Chapter 3

Responses to Comments

This chapter includes responses for each of the numbered comments identified in the comment letters in Chapter 2, *Comments Received on the Draft EIR*.

Figure A-10a
Changes in Byproduct Concentrations

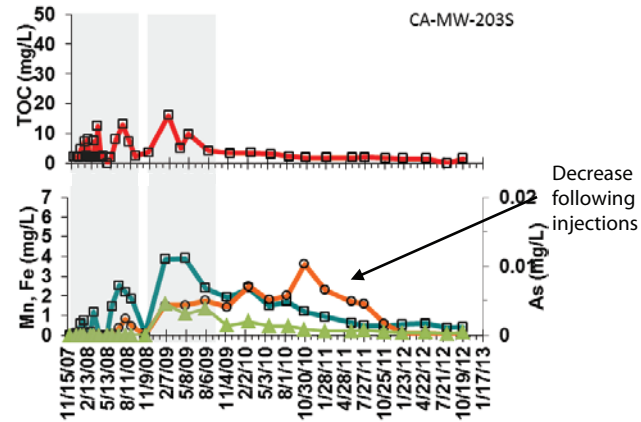
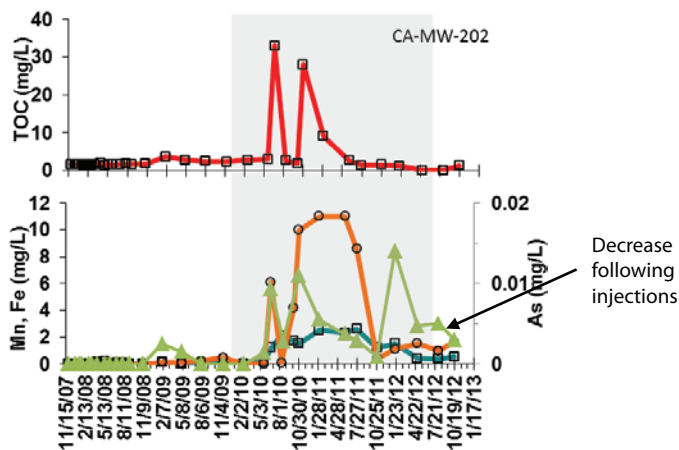
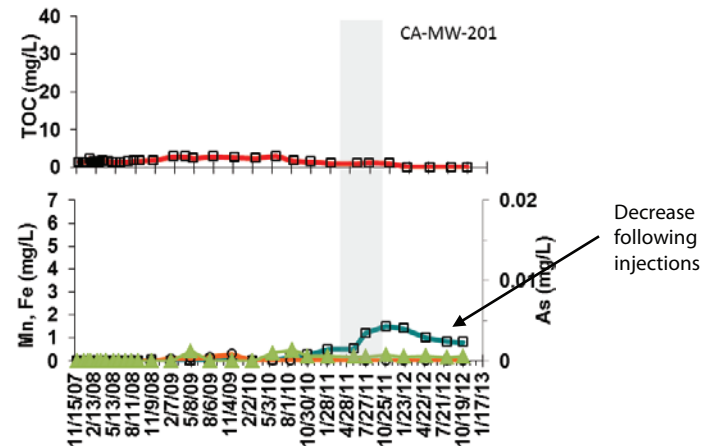
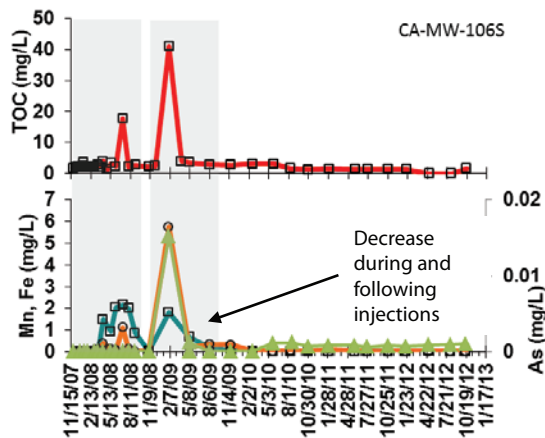
7 **Reduction in Byproducts Over Time.** As explained in the Draft EIR and Appendix A to the Draft
8 EIR, although carbon injection changes the levels of byproducts in the aquifer, this change is
9 temporary and levels dissipate on the order of several months to years. When organic carbon is
10 injected for remediation and consumed by microbial action, reducing conditions increase. This
11 results in increases in byproduct formation and concentration. Generally, manganese is the first
12 byproduct to form, followed by arsenic and iron. As reducing conditions decrease or as the
13 byproducts migrate into oxygenated groundwater, the concentrations of byproducts (iron,
14 manganese, and arsenic) begin to return to pre-dosing concentrations through a number of
15 processes including dilution, sorption, precipitation and coprecipitation. Once organic carbon
16 injections cease, aerobic conditions return in the treatment area (due to mixing of groundwater with

17 dissolved oxygen content), resulting in further decreases of byproduct concentrations as dissolved
18 iron and manganese are reoxidized, reforming oxide minerals. The figure below (based on sampling
19 done at various times during IRZ pilot operations shows that when total organic carbon (TOC) levels
20 decline, then arsenic, manganese and iron concentrations also decline over a period of several
21 months to a year or slightly longer. This figure has been added to Appendix A of the Draft EIR as
22 Figure A-10.

9 **Table 3-2: Transect 1 Sampling Results (From Source Area IRZ to the Northwest, Q3/Q4 2012 sampling)**

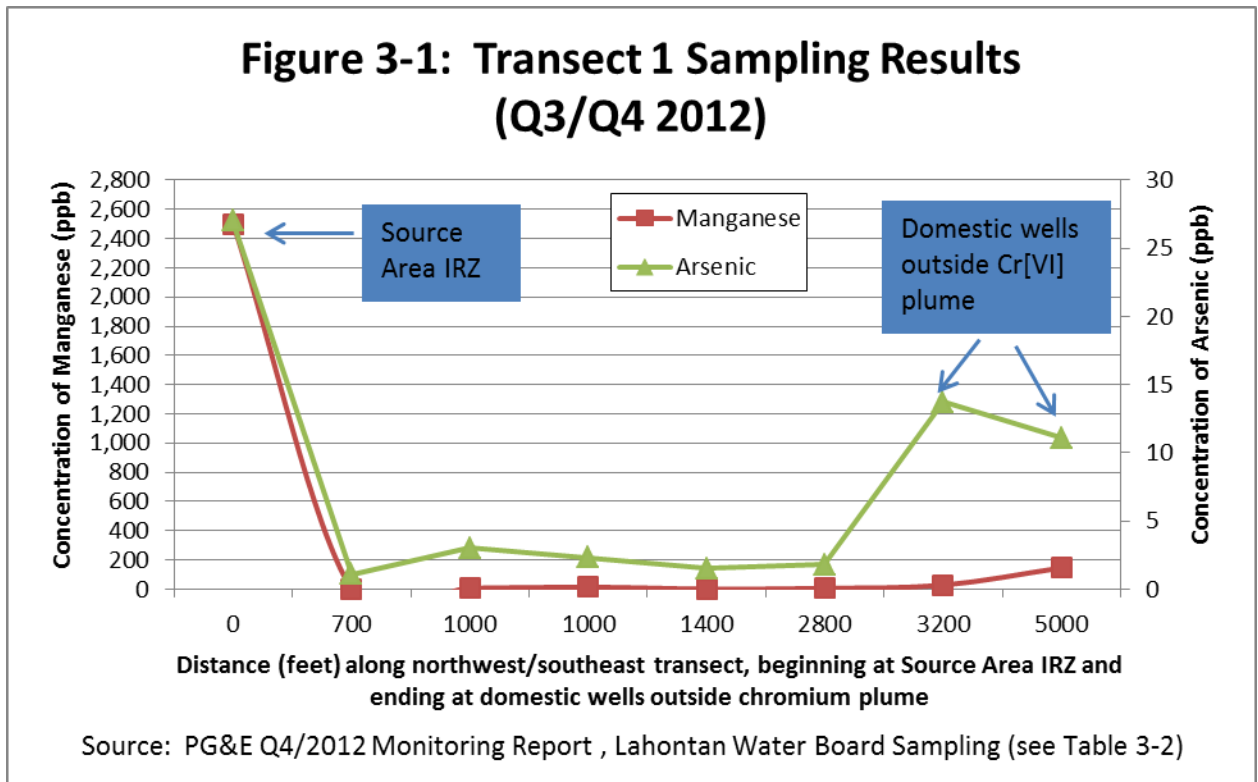
- 31 • **Monitoring Results - Manganese.** The manganese distribution within and outside of the IRZ
32 area does not appear to support a conclusion that manganese has migrated from the IRZ to
33 areas outside the plume. Figures 3-1 and 3-2 and Tables 3-2 and 3-3 in this section show
34 sampling data from 2012 along two transects. Transect 1 starts near the Source Area IRZ
35 injection points and then proceeds northwest to the edge of the chromium plume and then to
36 the nearest domestic wells outside the chromium plume. Transect 2 starts near the Central Area
